### **REMARKS**

Claims 1-11, 13-17, 19-35, and 37-52 were pending in the above identified application. The Examiner has rejected claims 1-11, 13-17, 19-35, and 37-52. Applicant has amended claims 1-4, 6, 8-11, 15-17, 21-27, 32-33, 35, 38, 40-44, 46, and 48-49 and canceled claims 19-20, 31, 34, 37, 39, 45, and 51-52. These amendments were made in order to clarify the claims. No new matter has been added. Claims 1-11, 13-17, 21-30, 32-33, 35, 38, 40-44, and 46-50 remain pending after entry of these amendments

### **AMENDMENTS TO THE DRAWINGS:**

FIG. 2B

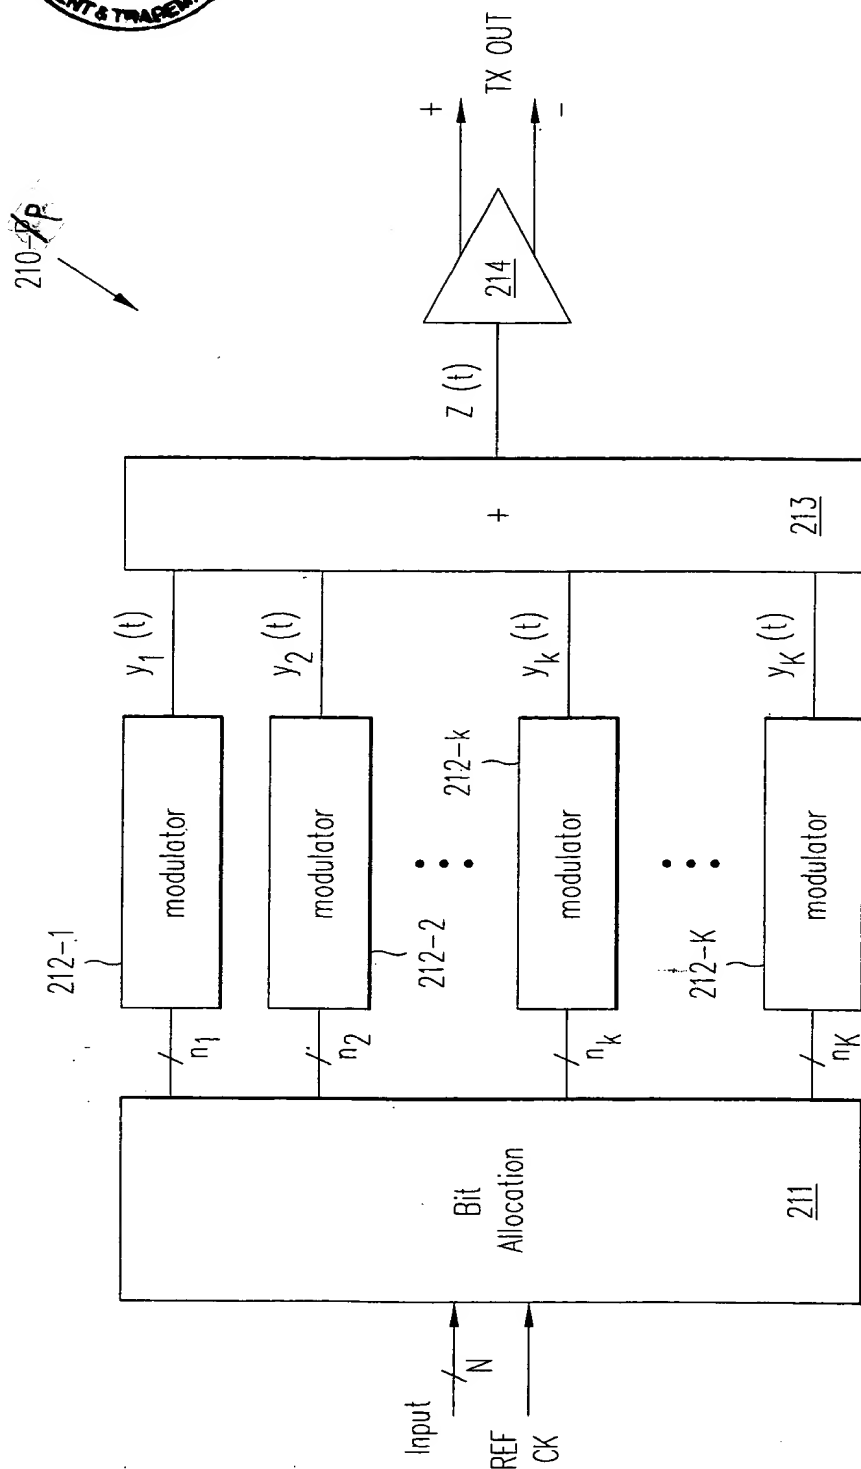
The Examiner has objected to the drawings because “Fig. 2 still contains multiple references to 201-P, and 210-P.” Applicant respectfully points out that after the last amendment filed February 15, 2005, Fig. 2A now contains one reference each to 201-P, 210-P, and 220-P. Fig. 2A also contains one reference each to 201-p, 210-p, and 220-p. This labeling follows a convention that uses upper case letters to denote constants and uses lower case letters to denote variables. In this case the total number of devices connected to the transmission medium is denoted by the constant P. The labels 201-p, 210-p, and 220-p refer to an arbitrary device chosen from the set of devices and labeled with an integer between 1 and P. This convention is used to explain the figures in the portion of the specification that describes the drawings. Applicant respectfully requests that the Examiner remove the objection to the drawings.

Figures 2B, 2C, 4, 5, and 9 have been amended to correct typographical errors. For completeness, all of the formal figures are being submitted with this response.

The attached sheets of drawings include changes to Figures 2B, 2C, 4, 5, and 9. These figures have been modified to correct for typos. Figure 2B has been modified to replace the label 210-P with 210-p. Figure 2C has been modified to replace the label 220-P with 220-p. Figure 4 has been modified to replace the label 212-R with 212-k and to delete an extra parenthesis from the caption for multiplier 410. Figure 5 has been modified to replace the label 222-K with 222-k. Figure 9 has been modified to replace the label 210-P with 210-p and replace the label 220-P with 220-p. No new matter has been added by these corrections.
